TITLE: [PR-PC] Environmental Assessment Major Project 07-0179, Mixed Use Development, Lots 184 – 187 and 191 – 194 in DP 259164 and Lots 20-23 DP 31208, Tweed Coast Road and Hastings Road, Cabarita

FILE NO: DA2380/690 Pt5

SUMMARY OF REPORT:

The Department of Planning have invited Council to provide a submission regarding the EA. The following matters have been identified as being of importance to include in any submission to the Department.

CABARITA DEVELOPMENT | Basement Mezzanine Plan
 1:400 @ A3 | 23.04.09 | Dev. Application | DA-13 | F

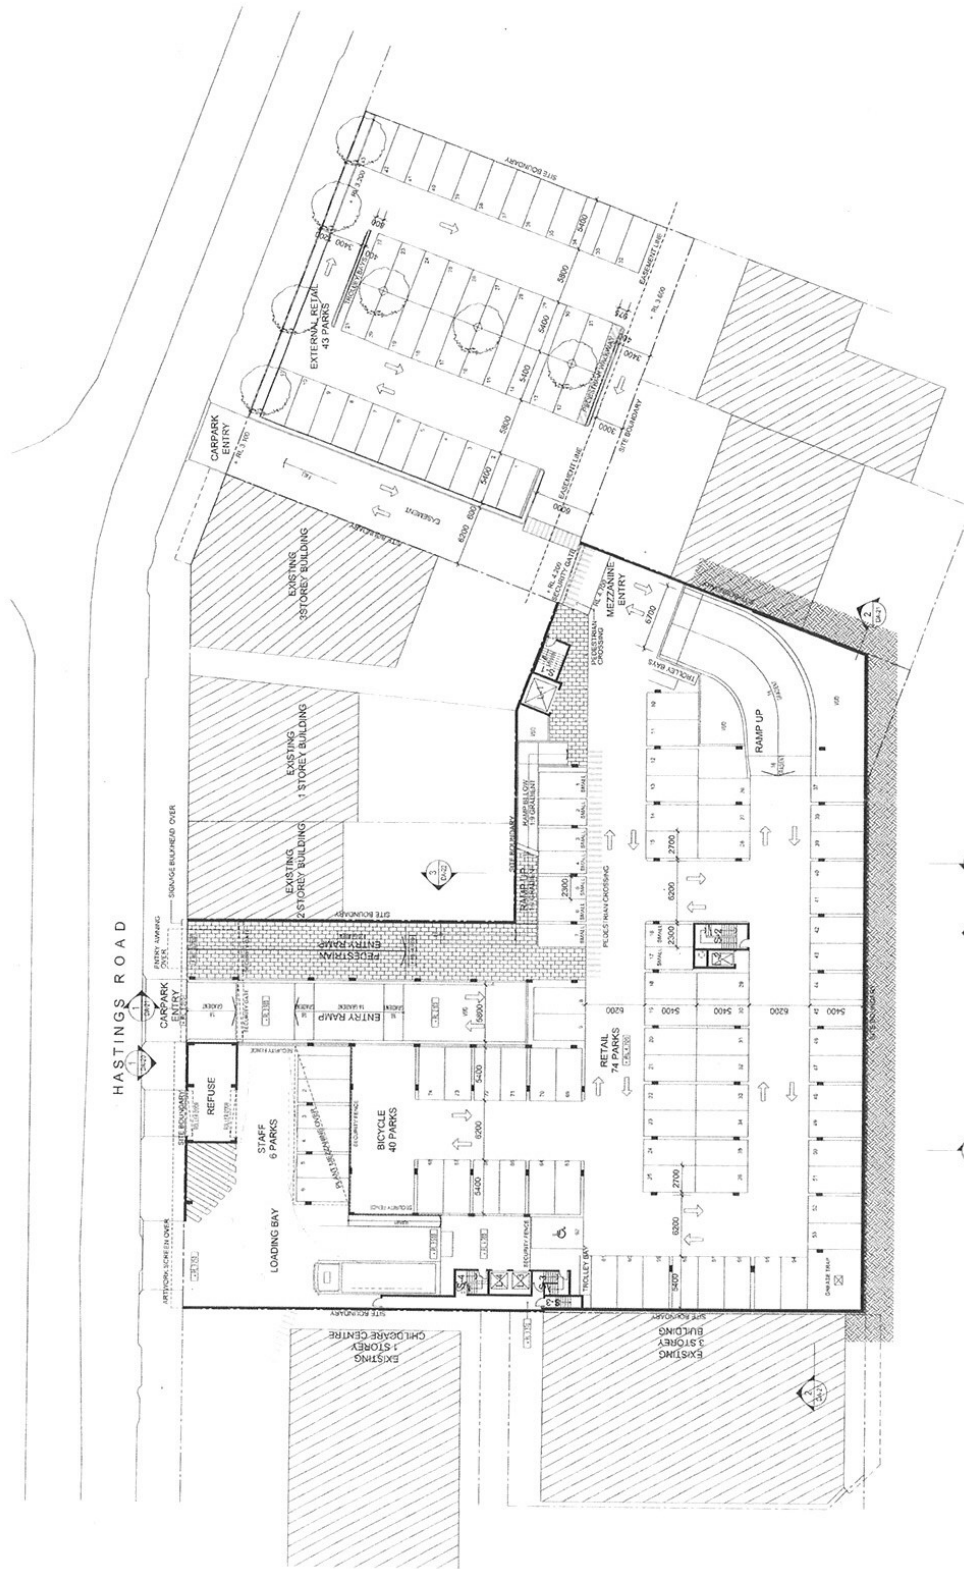
- The 12.5m heavy vehicle shown on plan no. DA13 revision F prepared by Stockwell does not demonstrate adequately that the vehicle can manoeuvre on site and enter and leave the site in a forward direction.

The applicant is requested to clearly demonstrate with turning templates for a 12.5m heavy vehicle that the vehicle can adequately manoeuvre on site and enter and leave the site in a forward direction. The detail is to be provided at a maximum scale of 1:200.
